## Technical Service Bulletin

No. D71-9-8

Piston Change

MODELS: 1971
Equipped With
440 C.I.D.
Std. Engine

Example: Engine Serial Pad

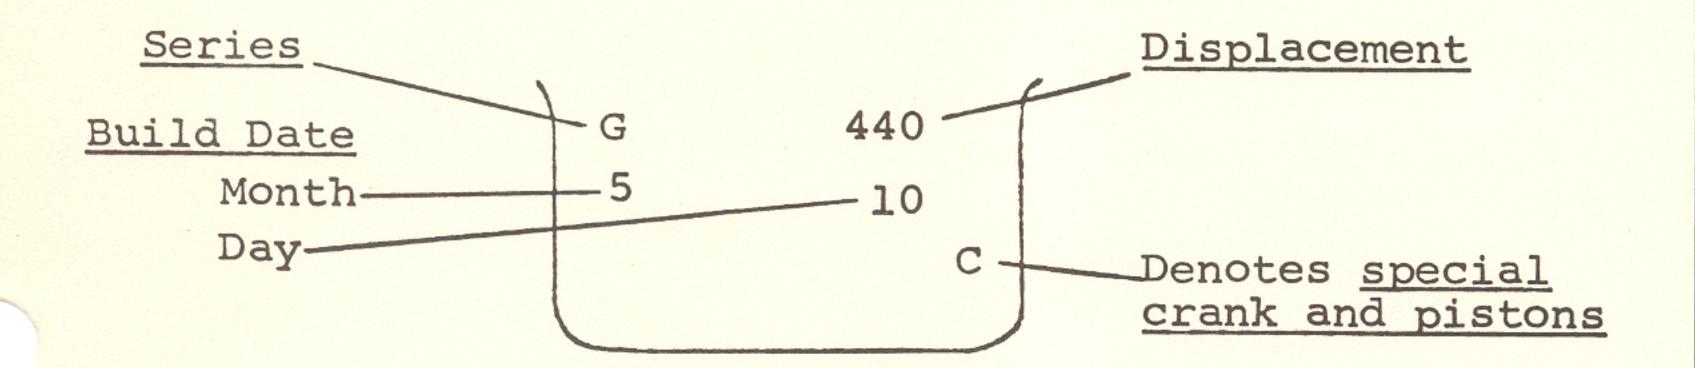
A new piston will be incorporated into production on the 440 C.I.D. standard engine late in 1971 production. This piston is lighter than the early piston so requires a new crankshaft. Severe engine vibration will result if the early crankshaft or piston is used in these engines.

The engines will be identified with the letter "C" on the information pad on the top, adjacent to the left bank and tappet rail as follows:

The new piston and crankshaft are serviced as shown below:
